**Garden City Design Review
Application Review**

**DSRFY2024-0002
34th Street Townhouses**

RESPONSE TO COMMENTS PER ARCHITECT 12/13/2023

DSRFY2024-0002

SCALE 1/4" = 1'-0"

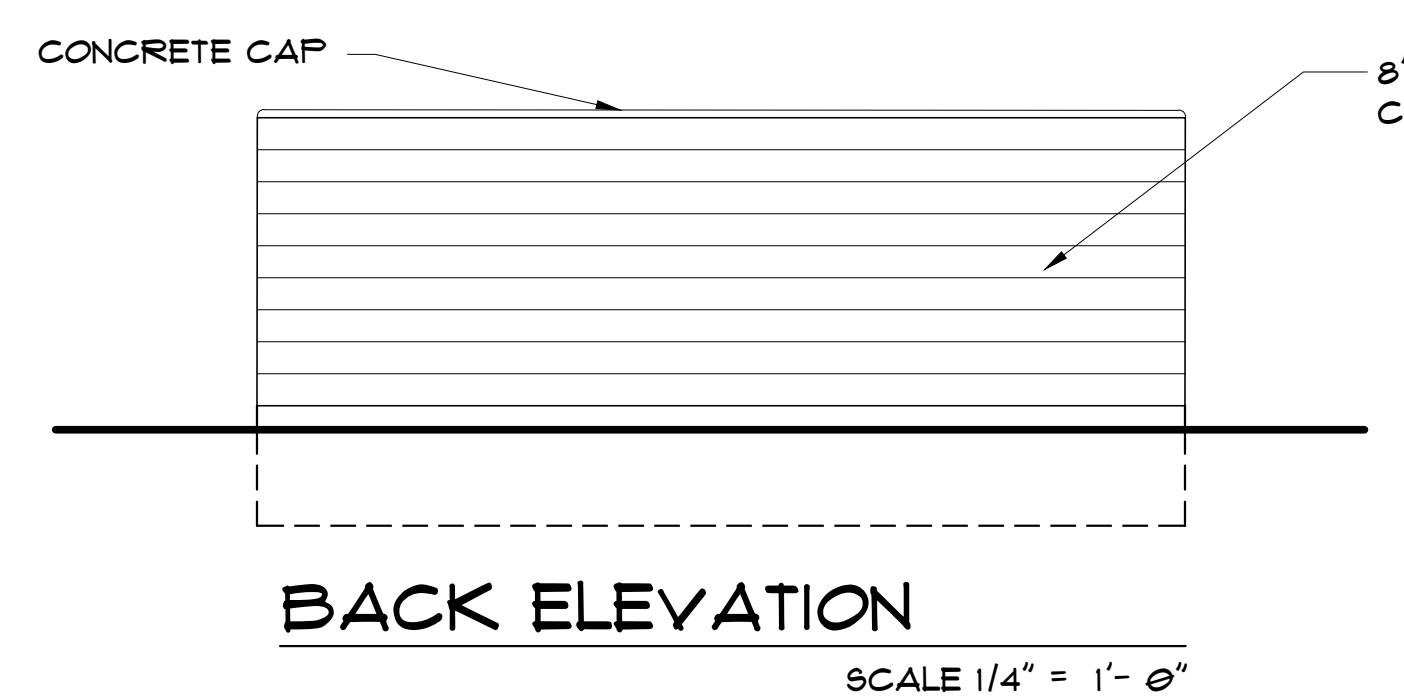
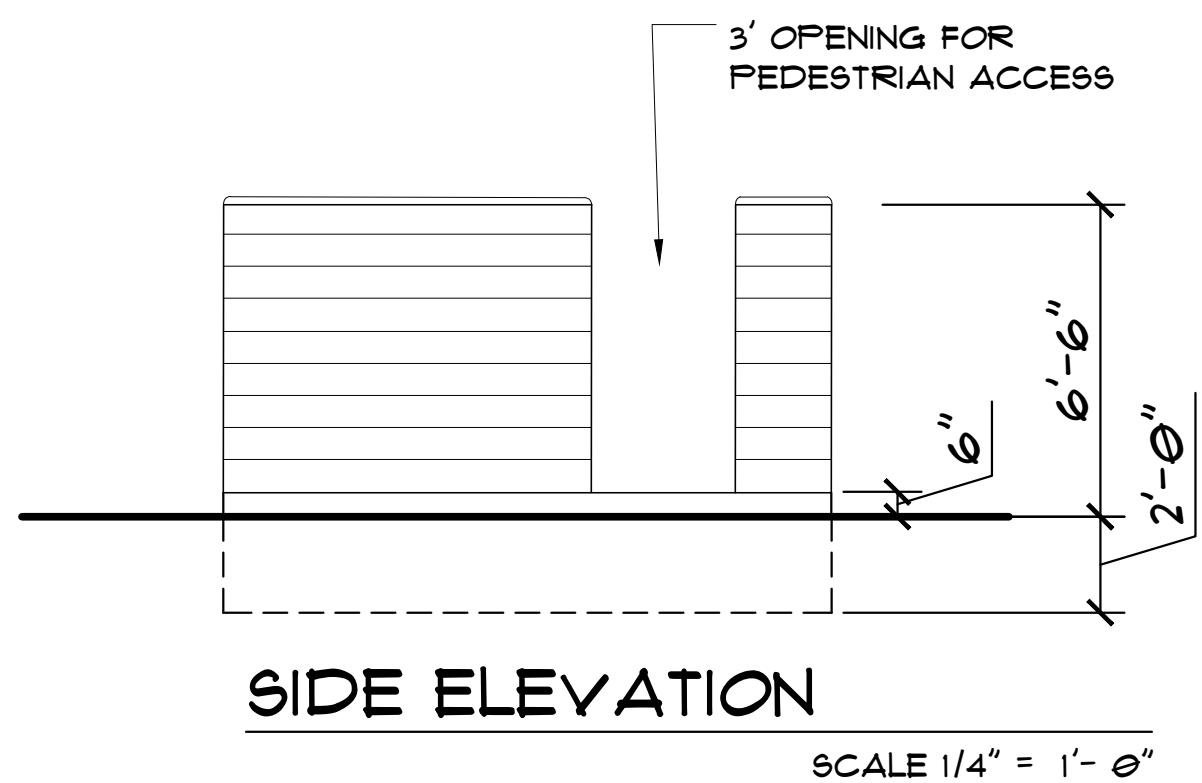
8. **Provide details/renderings/elevations of covered parking.** (TO BE PROVIDED BY MFGR. AND INSTALLER.)
9. **Provide details/renderings/elevations of trash enclosure & proposed screening.** (SEE SUBMITTED PLN. SHT.12)
